WCAP-16168-NP, Rev. 1
Project Number 694

Subject: Pressurized Water Reactor Owners Group
Responses to the NRC Request for Additional Information (RAI) on PWR Owners Group (PWROG) WCAP-16168-NP, Rev. 1 "Risk-Informed Extension of Reactor Vessel In-Service Inspection Interval" (TAC NO. MC9768) MUHP 5097/5098/5099 Task 2008/2059

REQUEST FOR ADDITIONAL INFORMATION

WCAP-16168-NP, REVISION 1, "RISK-INFORMED EXTENSION OF THE

Figure A-4300-2, Reference Fatigue Crack Growth Curves for Carbon and Low Alloy Ferritic Steels Exposed to Water Environments (From Appendix A of Section XI of the ASME BPV Code)

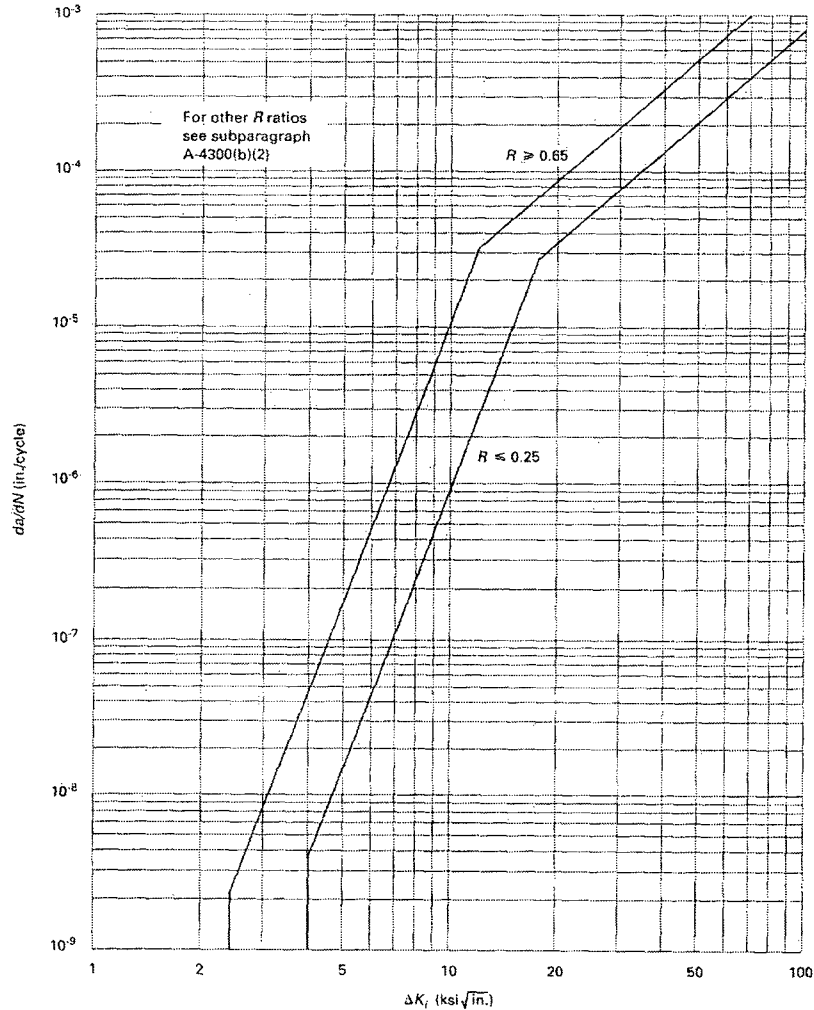
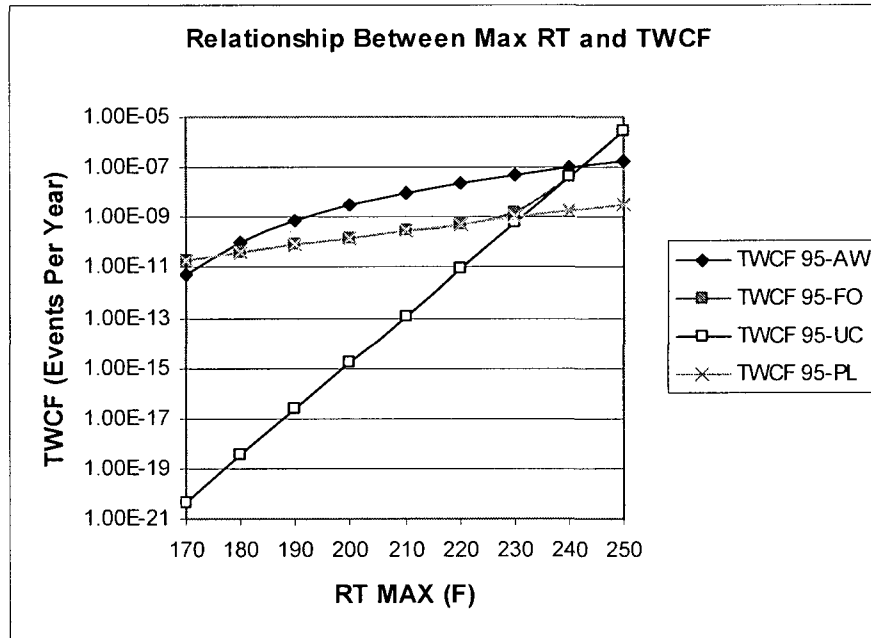
c) The staff requests that the WOG identify the fatigue crack growth curves (crack growth versus change in stress intensity factor) used in the pilot-plant studies.

Response: The fatigue crack growth rate equations for ferritic materials, such as the vessel wall base metal, are taken from Section 4.2.2 of the *Theoretical and Users Manual for pc-PRAISE* (NUREG/CR-5864, July 1992). As noted in this report, these “equations provide a probabilistic representation of the fatigue growth relationship for ferritic materials in water contained in Appendix A of Section XI of the ASME Boiler and Pressure Vessel Code.” Figure A-4300-2, Reference Fatigue Crack Growth Curves for Carbon and Low Alloy Ferritic Steels Exposed to Water Environments, from Appendix A to Section XI in the current edition of the ASME Boiler and Pressure Vessel Code, is also provided below for a graphical representation of these equations. It should be noted that the fatigue crack growth curves in Appendix A of Section XI of the ASME Boiler and Pressure Vessel Code have not changed since they were originally included in the 1978 Edition of Section XI. Furthermore, there are presently no known plans to revise the curves in the future.

In the above equations, R is K_{\min} / K_{\max} , ΔK is $K_{\max} - K_{\min}$ and C_F is normally distributed with a mean of 0 and standard deviation of one. The units on the applied stress intensity factor, K, are ksi-(inch)^{0.5} and inches per cycle on the crack growth rate, da/dN. Note that the normally distributed random value of C_F , which is used to calculate the uncertainty factor Q, is specified as input variable 14 (FCGR-UC) to the PROBSBFD Computer Program as first shown in Section C-1 in Appendix C of the WCAP Report.
